Rotor Panel Spare Part Number Changes

Issue	Date	Changes
1	04/07/2025	Technical parts bulletin created

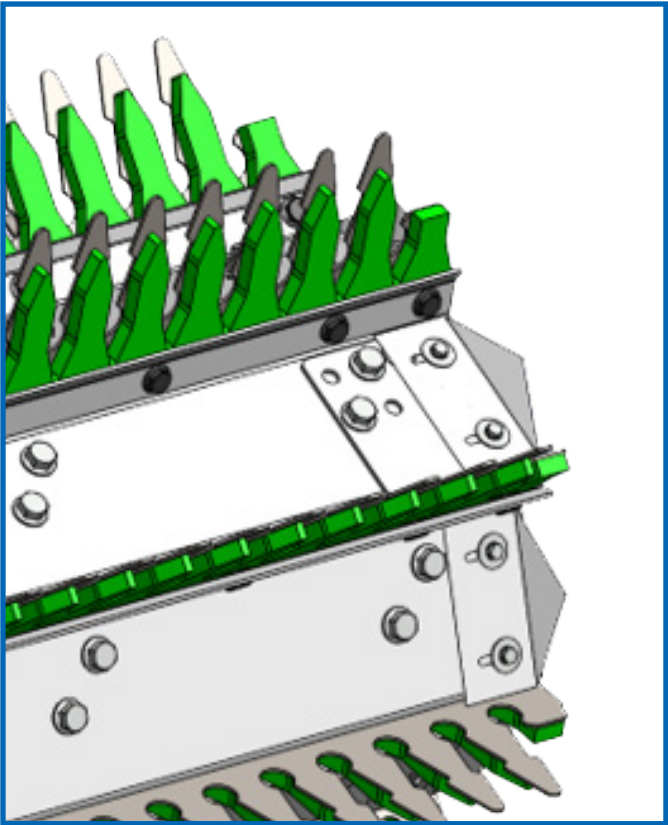
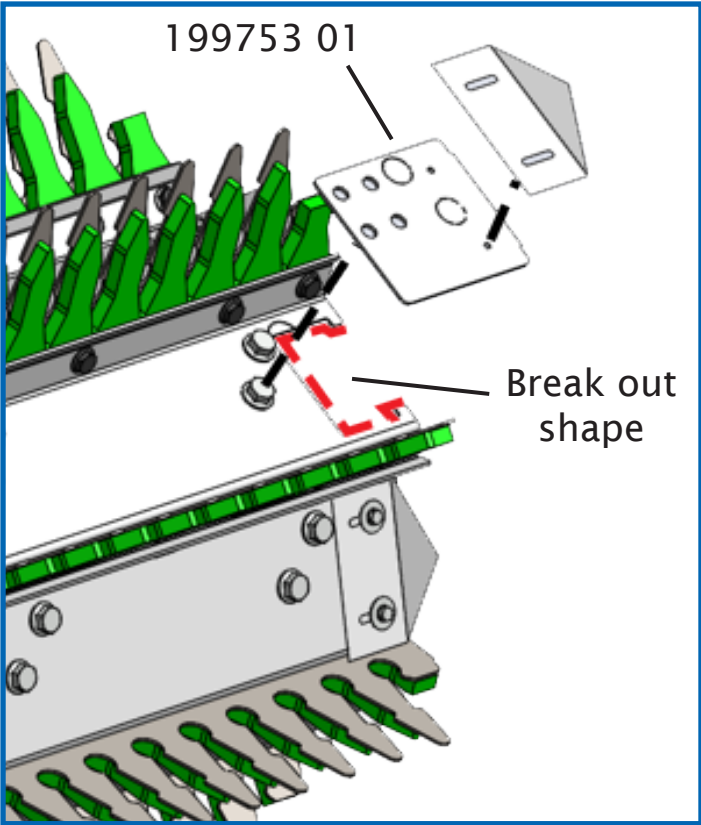
Stripping rotor panel spare part numbers have changed recently. See on page 2 a list of the original spare panel part numbers and the new.

New and old panels can be mixed on a rotor assembly.

The new spare parts have various knock out holes and sections so they can be broken out to produce the exact style of panel that is being replaced.

They also have an additional end knock out section that will assist with cleaning out debris that could get into the end of the rotor assembly.

If this facility is wanted on pre 2025 headers, then break out both ends on 2 panels and fit panels on directly opposite faces of the rotor assembly.

Additional cover plates (Part no. 199753 01 x 4 / rotor) will also be required to cover the clean out holes.
